Release Note. (CP4 3.2.0)

date : 2020.07.23

H/W : CP4, CP4S

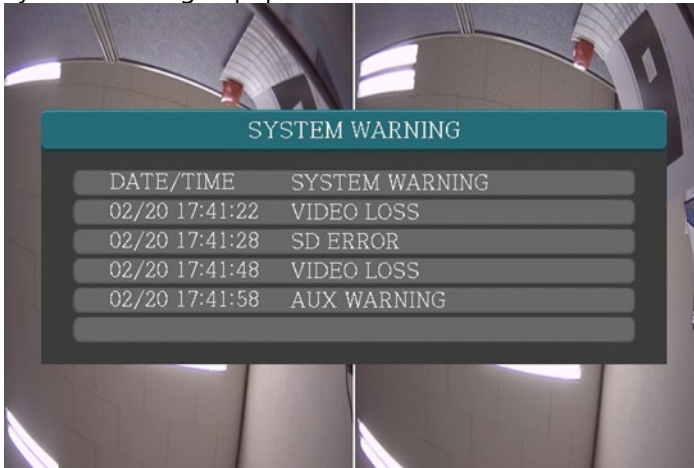
- 15) PANIC event is available on menu and popup screen.

PANIC event is activated when pressing the button more than 1 second.

- xi. Available on Event Menu

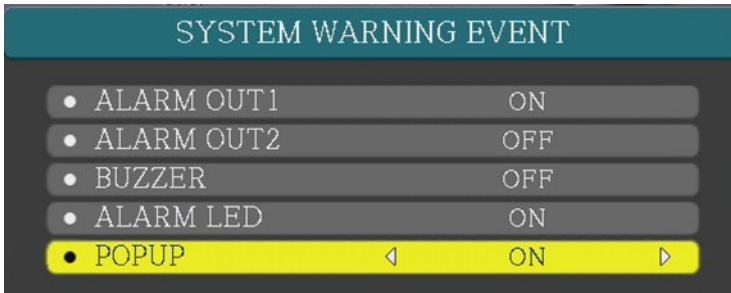
- Duration is initialized when another event is occurred within the duration.
- The list is initialized after the duration.
- vi. Pop-up window and warning list are initialized when pressing ESC button.
- vii. Pop-up window is not removed even the warning event is recovered.
- viii. Warning is displayed again when the event is occurred again from recovery.
- ix. System warning pop-up windows is only available on Live screen.
 - It is not available on Playback, Menu, another pop-up window on Live.
 - In the above condition, pop-up window is not displayed and event is not recorded, neither.
- x. System Warning Popup Windows

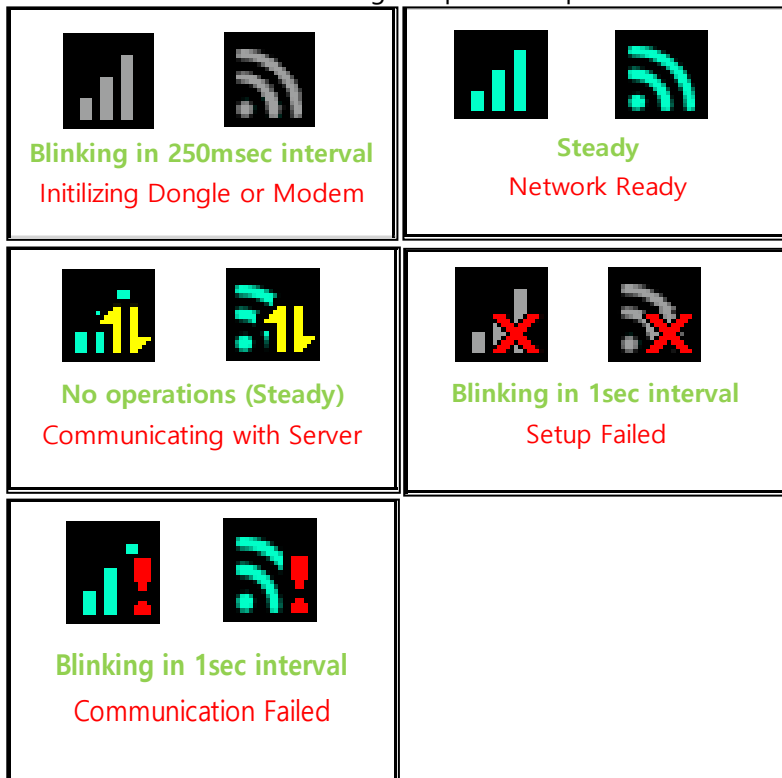
- 1) Network Status Icon and LED signal operation updated
